GE Energy

MFN 06-135
Supplement 2

Subject: Response to Portion of RAI Letter Number 20 Related to ESBWR Design Certification Application – Seismic Design – RAI Numbers 3.7-6S01 and 3.7-48S02

RAI Numbers 3.7-6S01 and 3.7-48S02

Figure 3.7-6 (1) FRS (Effect of Single Envelope Ground Motion) – RBFB Refueling Floor X

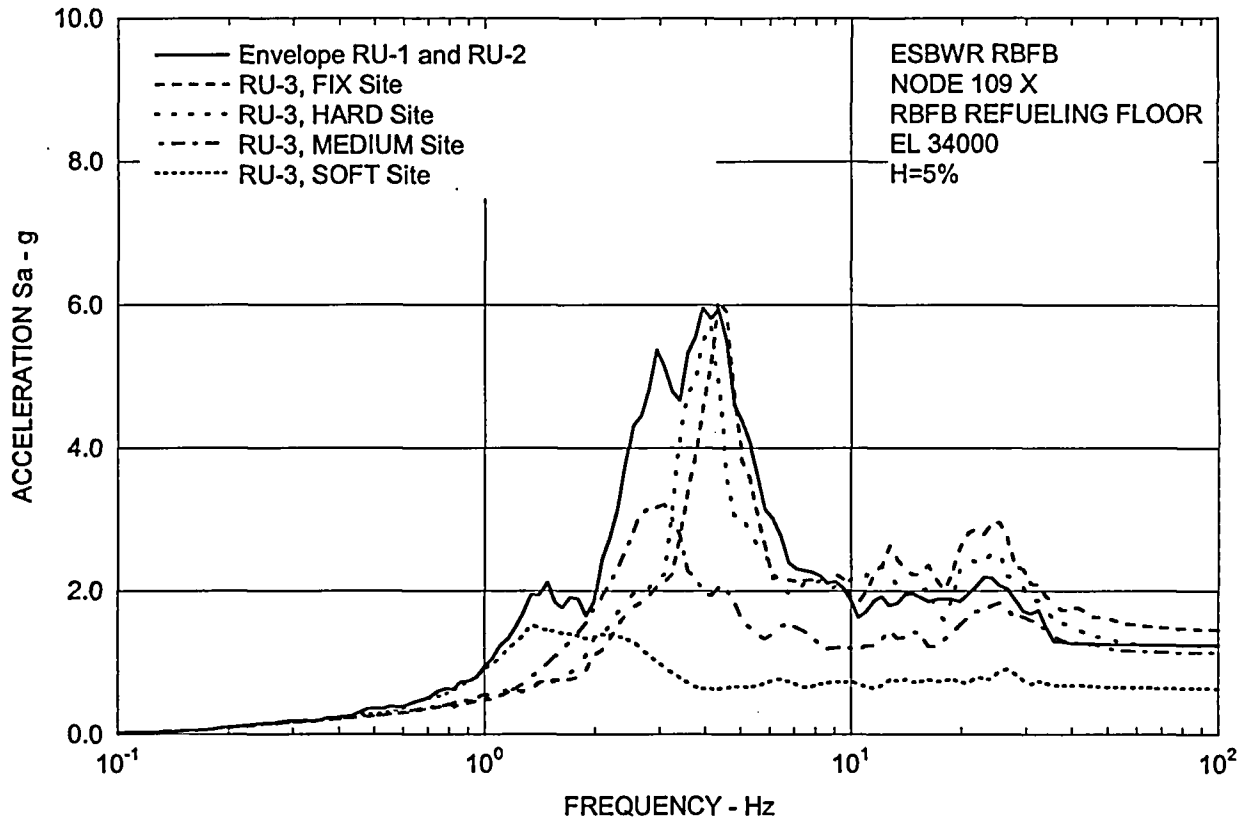
Provide justification for the difference in peak amplitudes of the floor response spectra between the single envelope input spectra and the separate RG 1.60 and North Anna spectra.

Figure 3.7-6 (1) shows the floor response spectra associated with this comment. There are differences in spectral peaks at about 3 Hz and 11 Hz.

The above discussion explains the differences in spectral peaks around 3 Hz and 11 Hz for the medium site FRS for the RBFB between RG 1.60 input motion, North Anna input motion and Single Envelope input motion. The final design is based on the envelope of all soil cases analyzed.

Figure 3.7-48 (1) Passive Soil pressure for Energy Components of Embedment

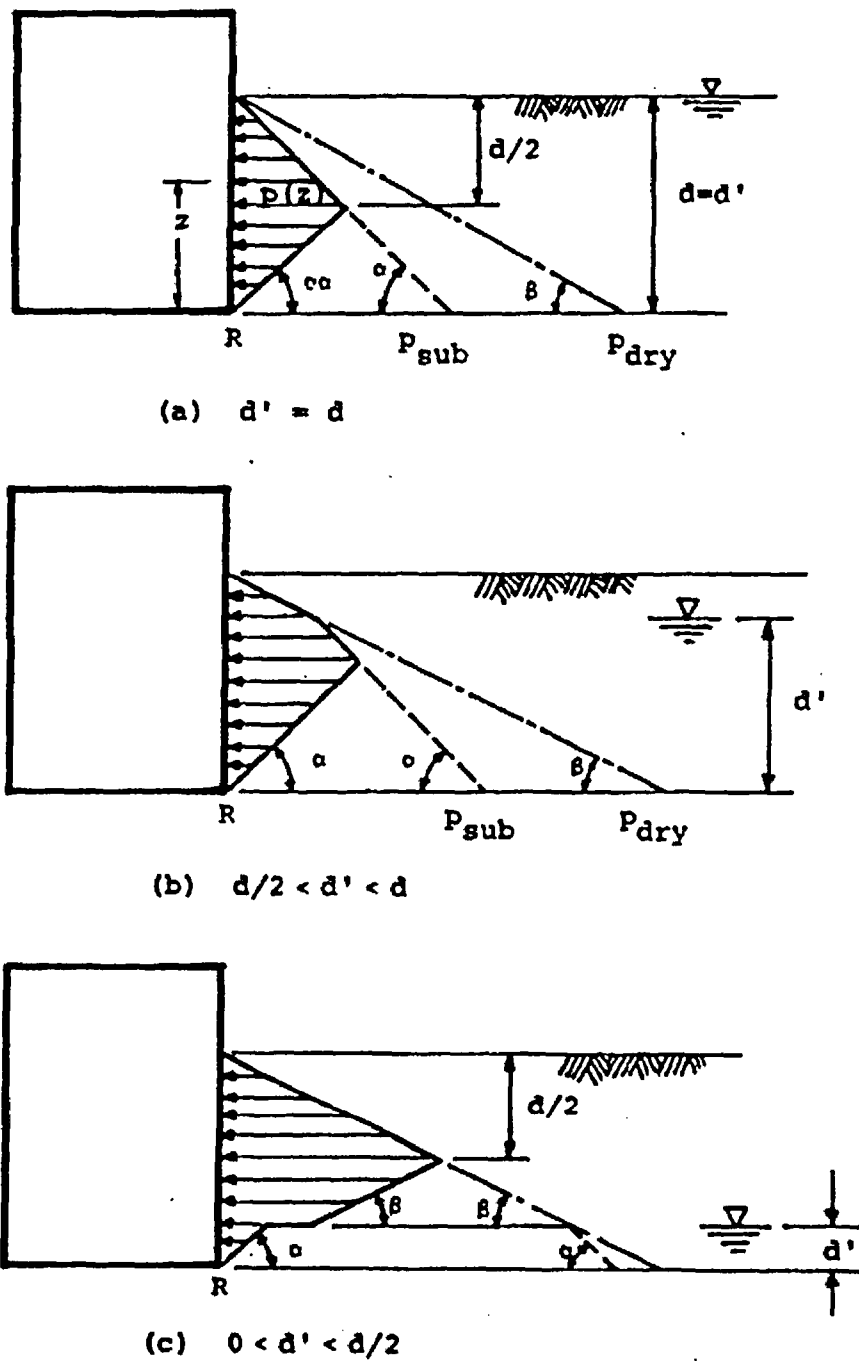
In DCD Section 3.7.2.14, the applicant described the use of an energy method to evaluate the stability of structures against seismically induced overturning moments. The applicant is requested to provide a more detailed description of the analysis method, including an explanation of how the energy components for the embedment (W_p) and buoyancy (W_b) are determined, and the technical justification for the two equations given for the velocity terms (V_h and V_v).

Energy components for the embedment (W_p) is illustrated in Figure 3.7-48 (1).

Let d be the depth of embedment and d' be the submerged depth in case the ground water table is above the elevation of the base. The structure is assumed to rotate about the toe edge R (or L) for the overturning evaluation. To simplify the analysis for practical purposes, only the passive soil pressure developed on the toe-side is considered, and the wall frictions and the rather complicated actions of the soil on the other side of the structure are neglected. The passive pressure diagram conventionally constructed would be modified to be consistent with the assumption that the structure rotates about the edge R . Granular and free-draining soil conditions are also assumed. Figures 3.7-48 (1) (a) to (c) show the resultant idealized pressure diagram for different elevations of the ground water table when it is above the base (i.e., $d' > 0$). In these figures, the control parameter P_{dry} is given by:

For the structure to reach the overturning position, the additional work required to be done against the side soil is, according to Figure 3.7-48 (1) (a):

$$W_p = \int_0^d P(z)bz \tan \theta dz = b \tan \theta \int_0^d P(z)z dz \quad (3)$$

in which $p(z)$ is the idealized passive soil pressure at the elevation z above the base, θ is the angle of rotation at the overturning position, and b is the effective length of the structure normal to the plane of rotation. The effective length b is the structural dimension normal to the plane of rotation for rectangular structures, and 0.8 of the diameter for cylindrical structures. For the case that the ground water table is below the base, Eq. (3) gives:

$$W_{P(d' \leq 0)} = \frac{1}{8} P_{dry} b d^2 \tan \theta \quad (4)$$

$$W_{P(d' = d)} = \frac{1}{8} P_{sub} b d^2 \tan \theta \quad (5)$$

Figure 3.7-48 (2) Energy Components for Buoyancy

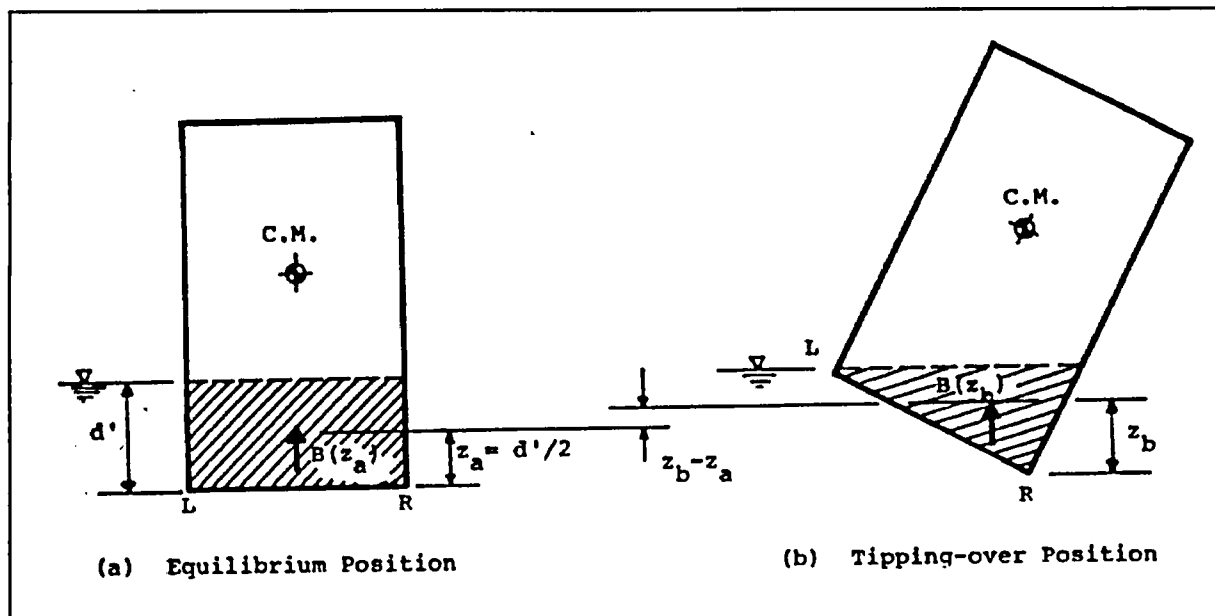
1. *Provide the corrected Equation 4-17 found in BC-TOP-4-A, Rev.3, Seismic Analyses of Structures and Equipment for Nuclear Power Plants, November 1974, Bechtel Power Corporation.*
2. *Provide the technical basis for using the SRSS method to combine the contribution from peak values of ground velocity and relative velocity.*

Energy components for the buoyancy (W_b) is illustrated in Figure 3.7-48 (2).

in which, according to Figure 3.7-48 (2), z_a and z_b are the height of the centroid of buoyant force above the edge R for the equilibrium position (a) and the tipping over position (b) respectively. Note that z_a is equal to $d'/2$. For practical purposes, Eq. (6) is approximated by:

$$W_b = (z_b + z_a)[B(z_b) - B(z_a)]/2 + B(z_a)(z_b - z_a) \quad (7)$$

1. GE found from its independent derivation that there is an error in Equation 4-17 in the above document. It should be corrected as follows:

(Corrected Equation) $W_b = (z_b - z_a)[B(z_b) - B(z_a)]/2 + B(z_a)(z_b - z_a)$
